**FRONT BRAKE CALIPER BOLT WASHER / FX, FXE, FXS**

A quantity of 1978 $\frac{1}{2}$  FX, FXE, FXS-1200 motorcycles were produced from January 12, 1978 to February 28, 1978 with defective front brake caliper washers.

FRONT BRAKE CALIPER ( LEFT SIDE SHOWN )

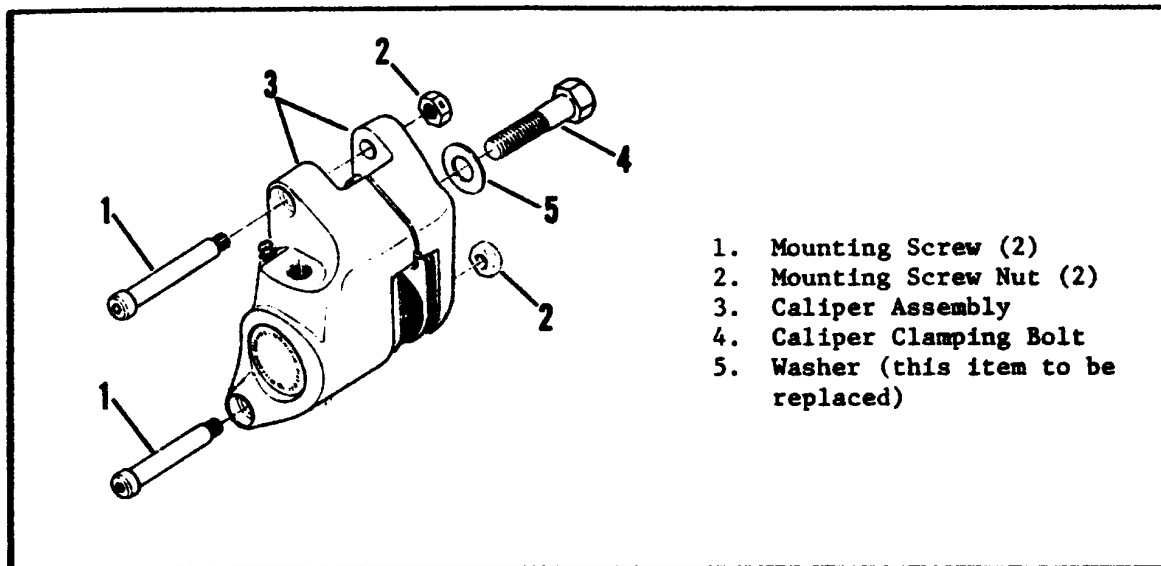
Inspect front brake calipers for correct washer. All large (.955 O.D.) washers are O.K. to use and need not be replaced. All small (.855 O.D.) washers must be replaced.

A caliper on one side must be removed first to provide access for servicing the opposite side caliper as follows: (See illustration).

1. Remove two left side caliper mounting screws (1) and nuts (2) with a 3/16" Allen wrench, detach left side caliper from fork slider. (Do not disconnect hydraulic brake line.)

2. Working through wheel spokes with a 5/8" hex socket and long extension, remove the right side caliper clamping bolt (4) and replace the washer using the correct (green) washer sent to you per Service Letter ML-80A. Torque right side caliper clamping bolt to 50 ft-lbs torque.

3. Reinstall the left side caliper on the left fork slider, applying Lock N' Seal, part No. 99625-77, to caliper mounting screw threads, and tighten screws to 115-120 in-lbs (10 ft-lbs) torque.

4. Remove right side caliper - same procedure as step 1.
5. Remove left side caliper clamping bolt and replace washer - same procedure as step 2.
6. Reinstall right side caliper - same procedure as step 3.

7. After assembly is completed, check front brakes for correct operation.
